**TOWN OF MOUNTAIN VILLAGE
SPECIAL DESIGN REVIEW BOARD MEETING
AGENDA**

THURSDAY APRIL 22, 2021 10:00 AM

5.	10:15	30	Miller Applicant	Quasi-Judicial	Consideration of a Design Review: Final Architecture Review for a new Single-Family Detached Condominium residence on Lot 165, Unit 10, 200 Cortina Drive, pursuant to CDC section 17.4.11.

Site Plan
and
Driveway Profile

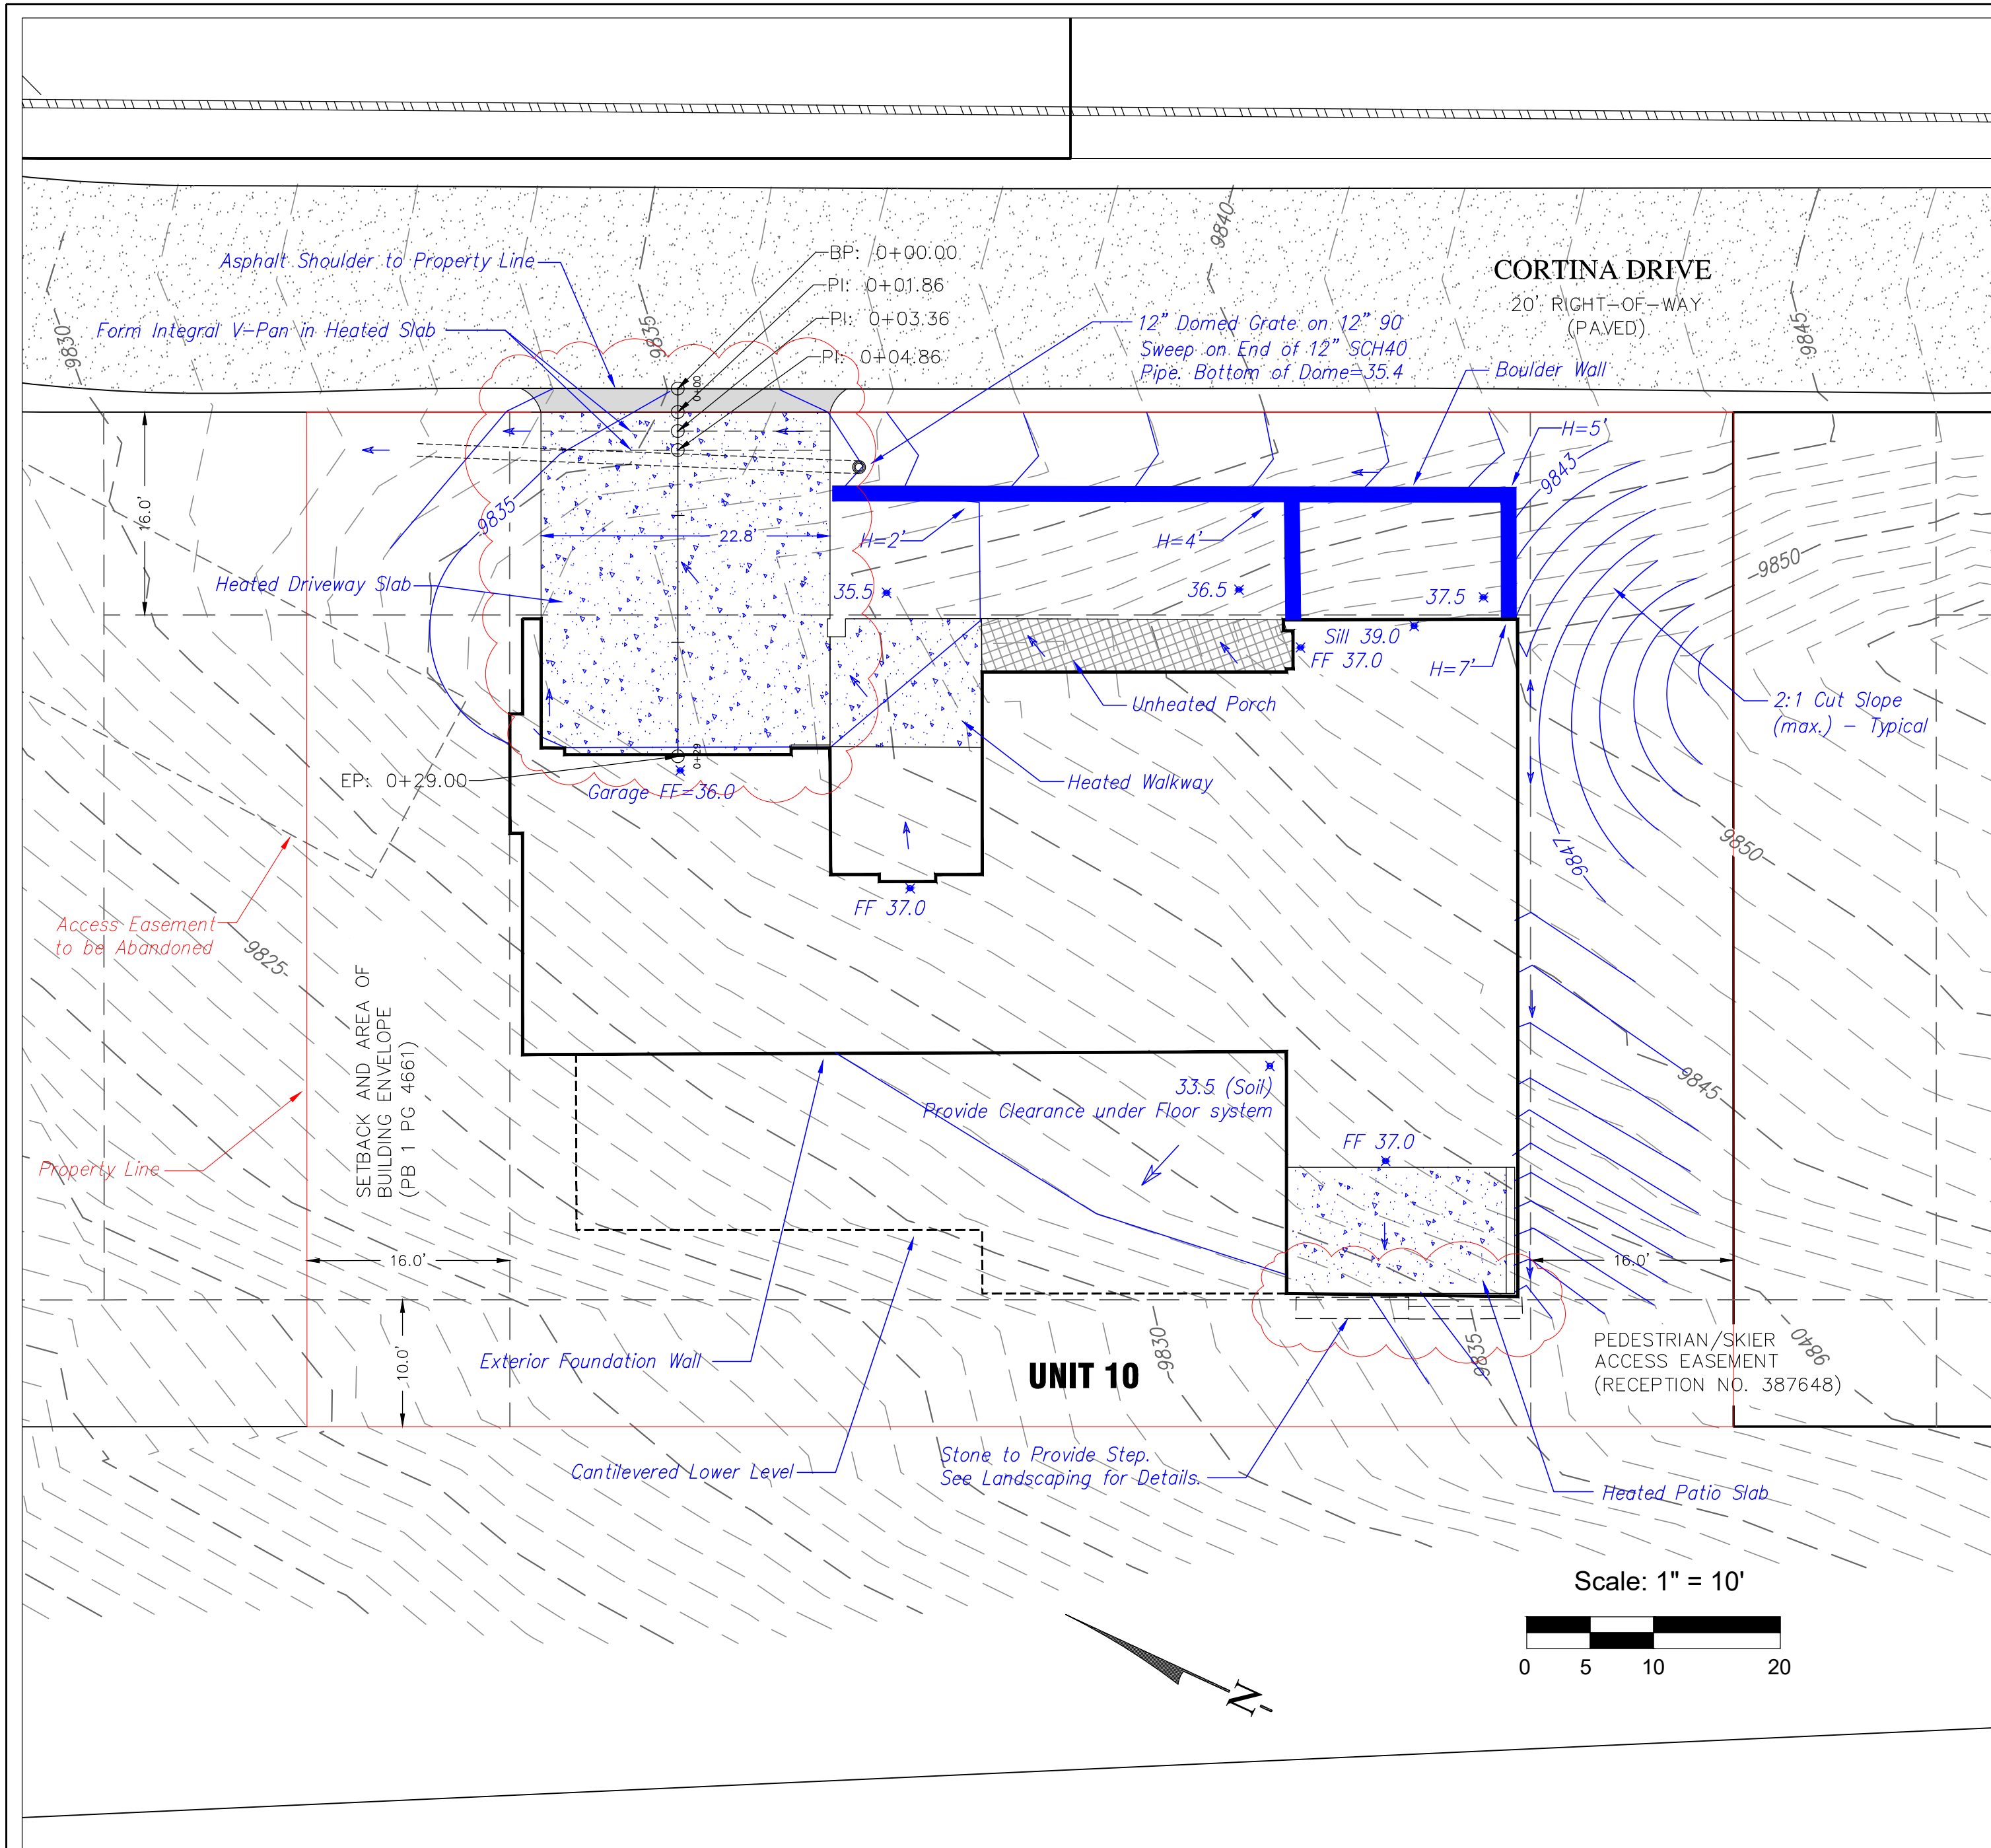
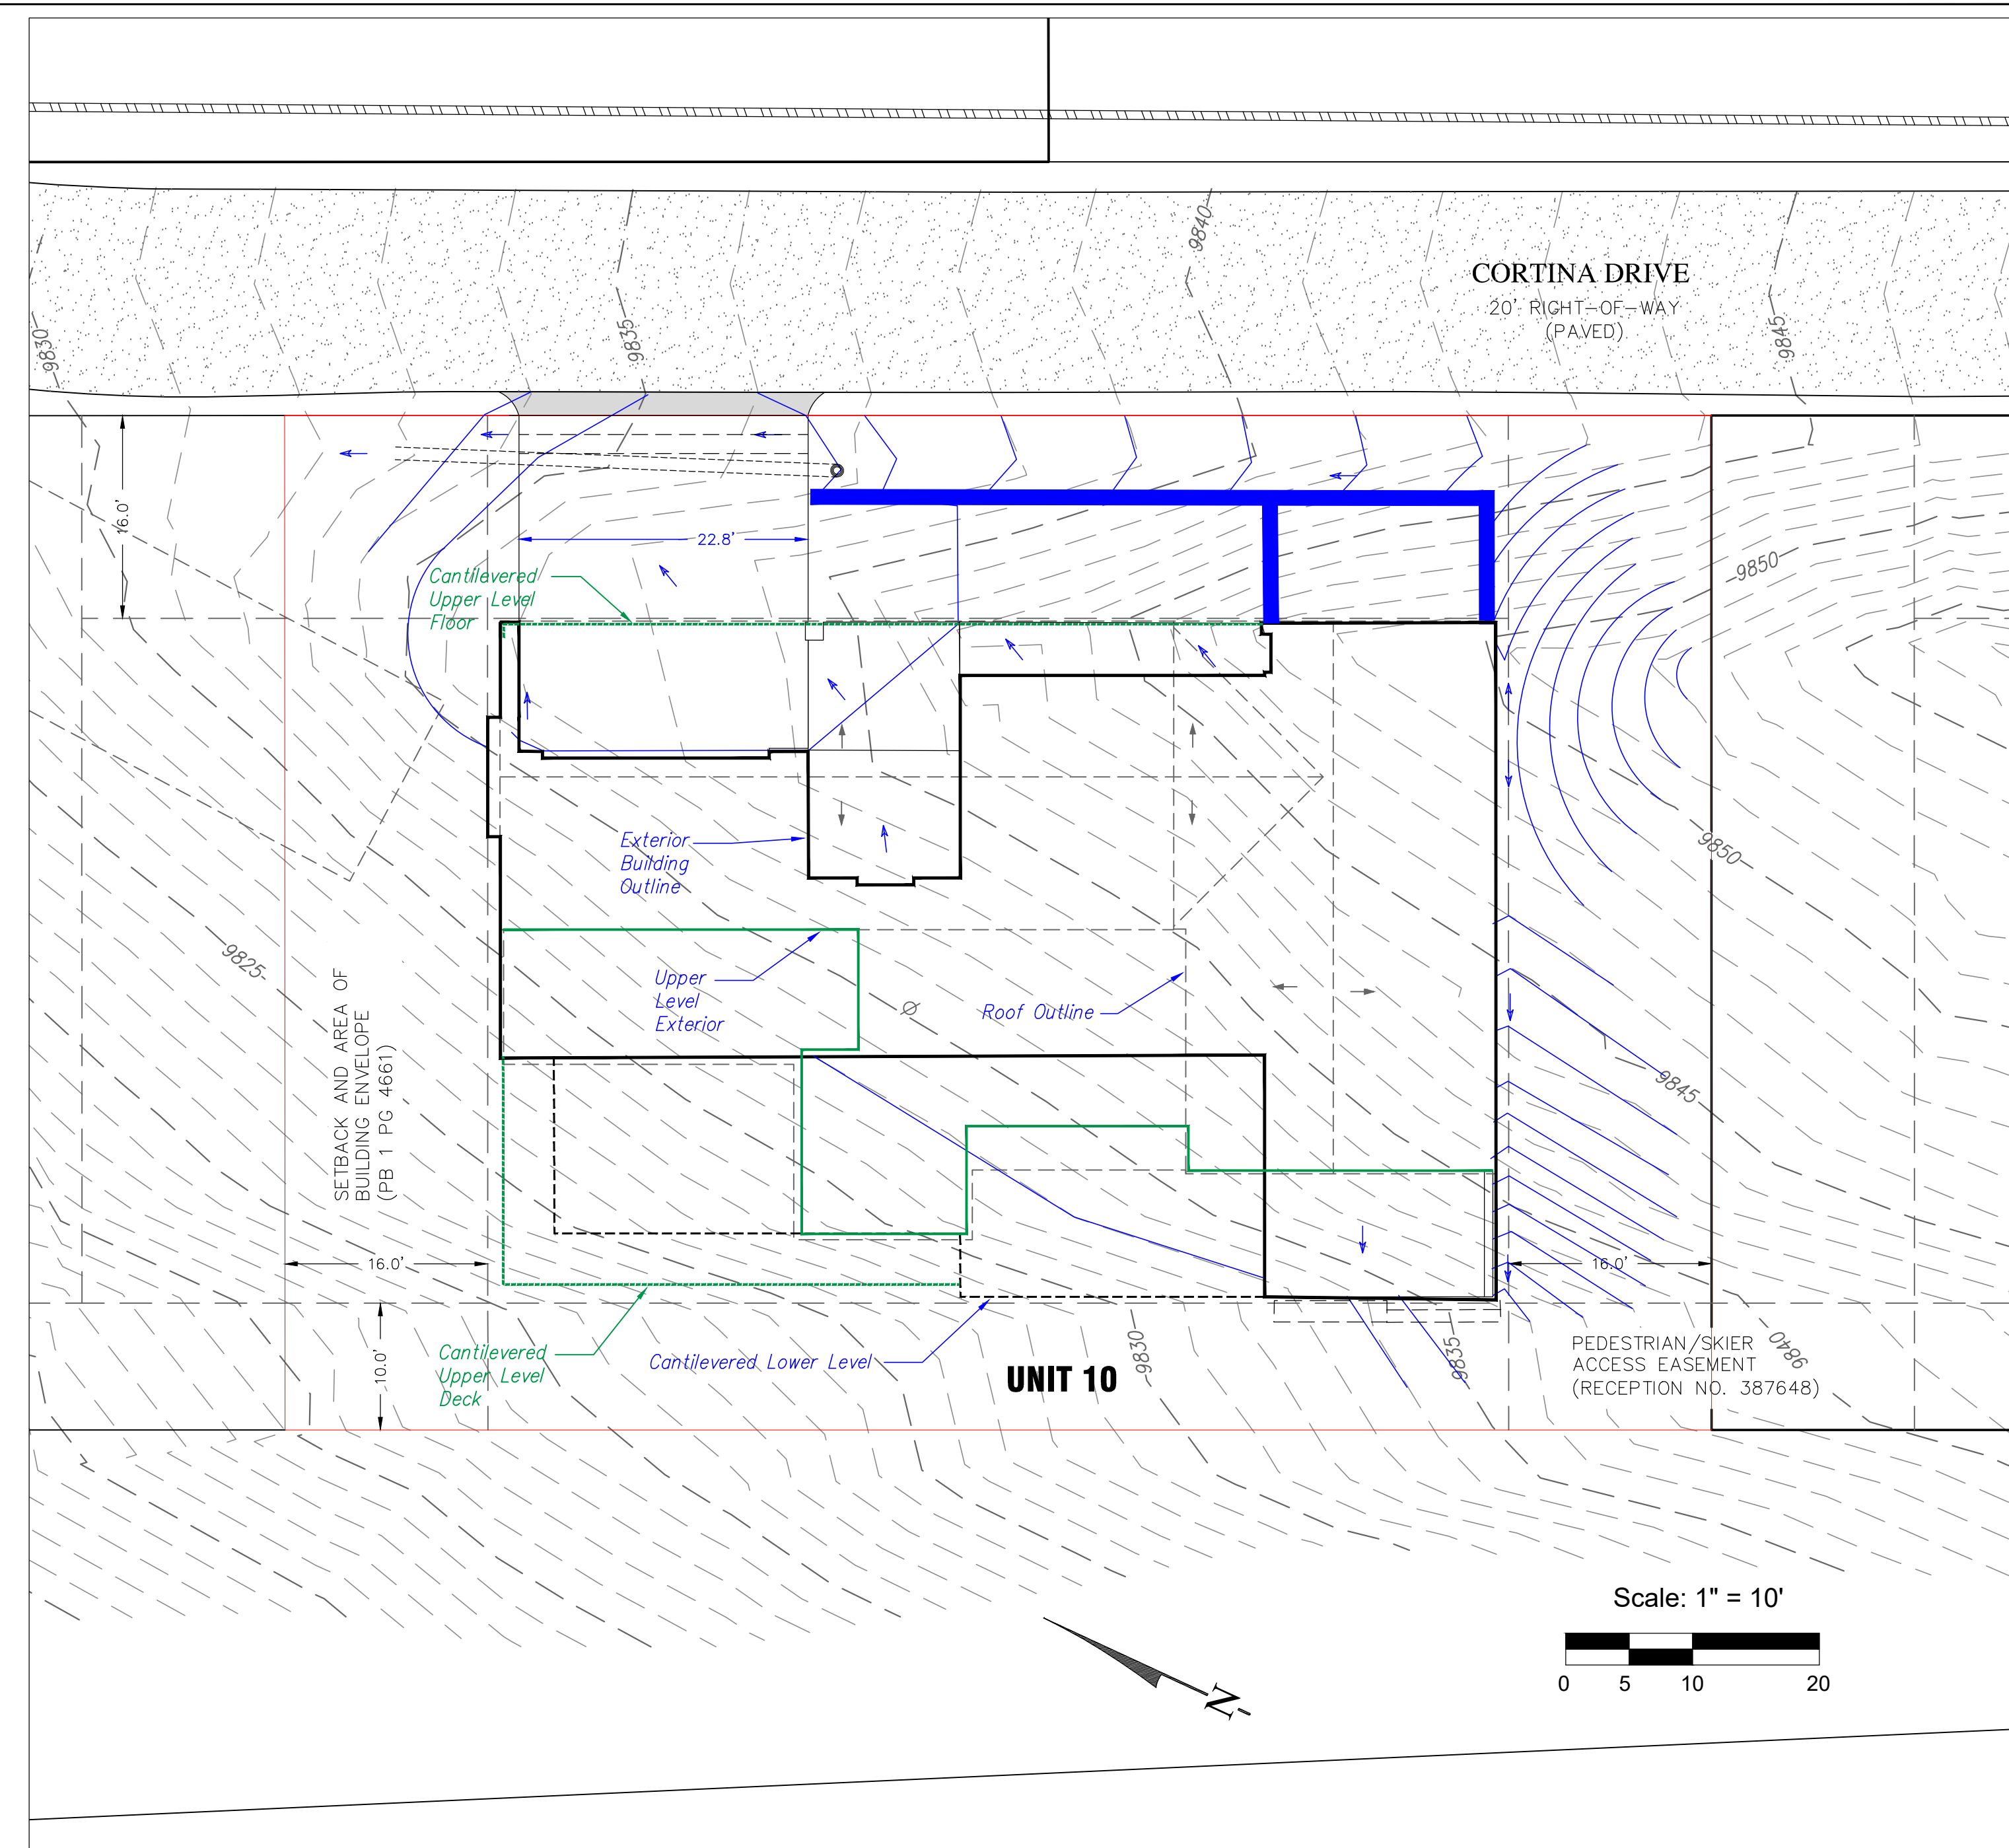
Staff: The applicant has provided a grading and drainage plan provided by Uncompahgre Engineering. The proposal documents the grade changes required around the home, including the finished slope calculations. As required by the CDC, all disturbed areas are to have final grades of 2:1 or less. The plan also demonstrates positive drainage away from the home in accordance with CDC requirements.
